AIR - HPT/LPT ACC SYSTEM - IMPROVED CONNECTION OF THE ACC ACTUATOR AND THE STATOR ROD
- CATEGORY CODE 4 - MOD.ENG-75-0009

V2500-ENG-75-0009

**SERVICE BULLETIN**

Replacement of bolt and removal of bush
Fig.1

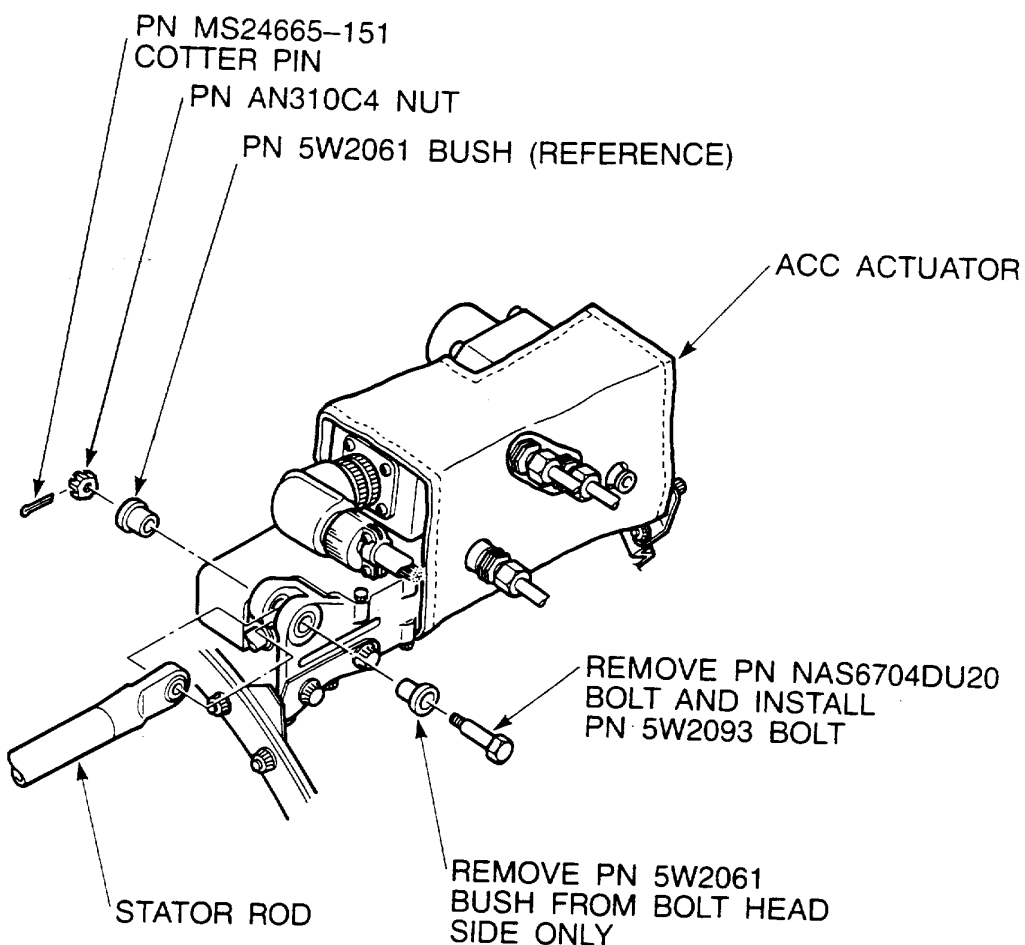
B. Replacement Instructions, refer to Figure 1.

- (1) Disconnect 5W8232 or 5W2096 Stator Rod from the ACC actuator.
 - (a) Remove MS24665-151 Cotter Pin, AN310C4 Nut and NAS6704DU20 Bolt.
- (2) Remove 5W2061 Bush from the ACC actuator.
 - (a) Draw the bush using the Puller, IAE1J13504.
- (3) Put the stator rod between the clevis of the ACC actuator.
- (4) Connect the stator rod.
 - (a) Align the holes of the stator rod and the clevis of ACC actuator. Install 5W2093 Bolt and AN310C4 nut.
 - (b) Torque the Nut to 32.5 to 42.5 lbfin (3,67 to 4,8 Nm).
 - (c) safety the nut with a new MS24665-151 Cotter Pin.
